DRC-2010-006304

December 9, 2010

SUBJECT: November 30, 2010 DRC Cell 4B Construction Inspection, Denison Mines (USA) Corporation (DUSA) White Mesa Mill Facility; November 24, 2010 DRC Letter, Regarding Cell 4B Construction; Construction Deficiencies Noted from Photographs

Photo 1. View to the NW corner of Cell 4B. This photo shows cushion geotextile on exterior of slimes drain header. Woven geotextile is the exterior fabric requirement for the slimes drain header, per drawing sheet 6 of 8; Section B-7. [Photo P1010028].

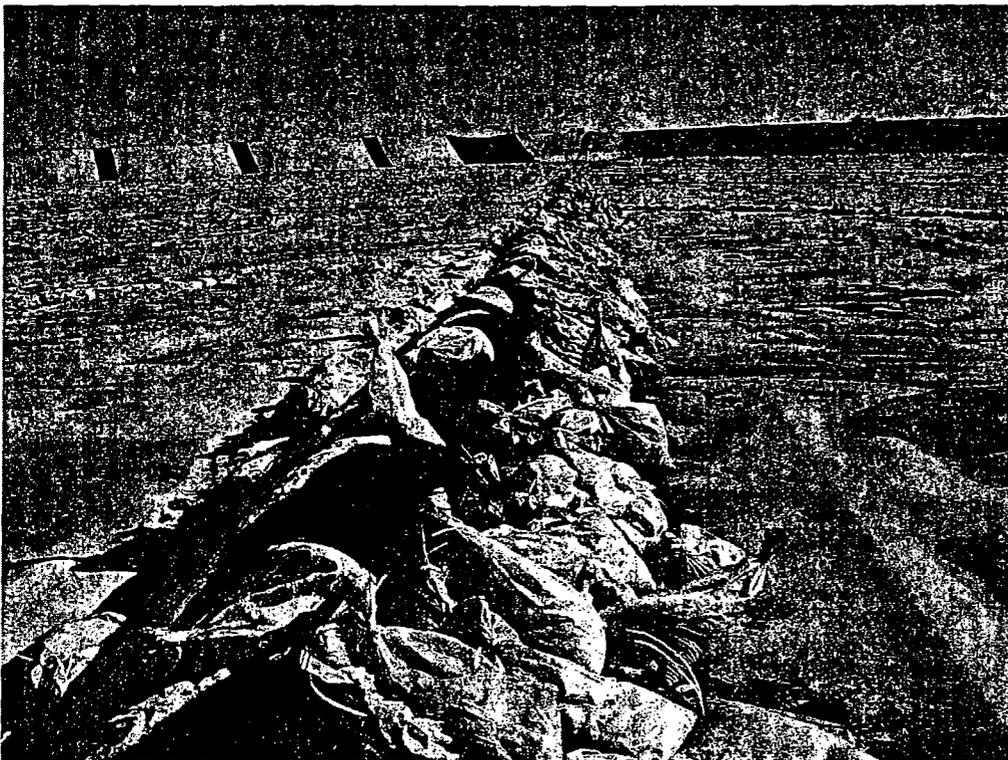
- a. *Improper Exterior Geotextile.* See Photo No. 1. This photo shows a portion of the slimes drain header. Cushion or non-woven geotextile is shown as the exterior cover of the slimes drain header. Conversely, woven geotextile is the required exterior fabric for the slimes drain header, per drawing sheet 6 of 8, Section B-7.

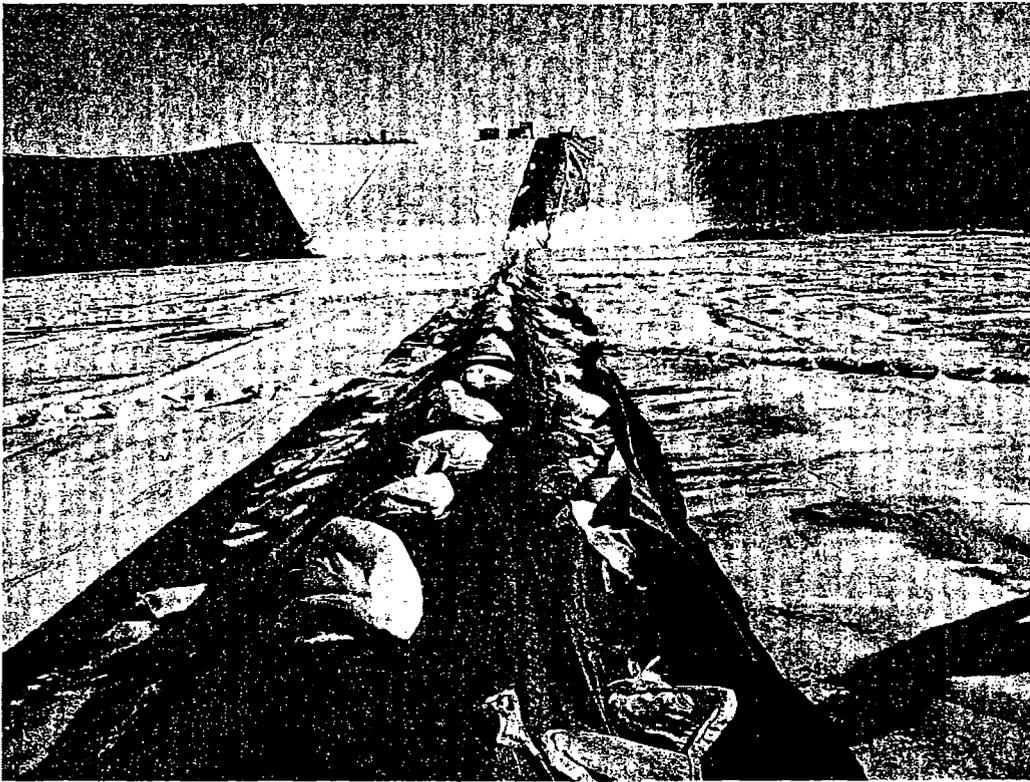
- a. *Using Larger Bags to Seal-off the Voids Created from the Piggy-backing of Smaller Bags.* See Photos 3, 4, and 6. Mr. Carlson of GeoSyntec proposed to Mr. Goble of DRC, that the larger bags could be used to seal off voids, created from use of the piggy-backing method used during installation of the smaller bags.

- b. *Piggy-backing of Larger Bags.* Photo No. 6 shows a longitudinal view of a strip-drain, which shows piggy-backing of larger bags onto smaller bags clearly. Also see Photo Nos. 3 and 4. Notwithstanding the issues discussed above, these photos show that many of the larger bags placed are actually being piggy-backed onto the existing smaller piggy-backed bags, preserving the void pathways to the slimes drains.

Photo 4. West side of Cell 4B. Possible "piggy-backed" larger bags are shown here. Note bags are Not always on both sides of the slimes drain. This method was proposed in the field for masking voids created by the smaller bags being "piggy-backed" as well. This photo is provided as an example, that this piggy-back type of placement is quite common in the other photos and observations made on 11-30-2010. [Photo P1010039].

If DUSA wishes to pursue DRC acceptance of this method, DUSA must submit a demonstration, for approval, that this method would be effective. Mr. Goble discussed this issue with Mr. Snyder on November 30, 2010.
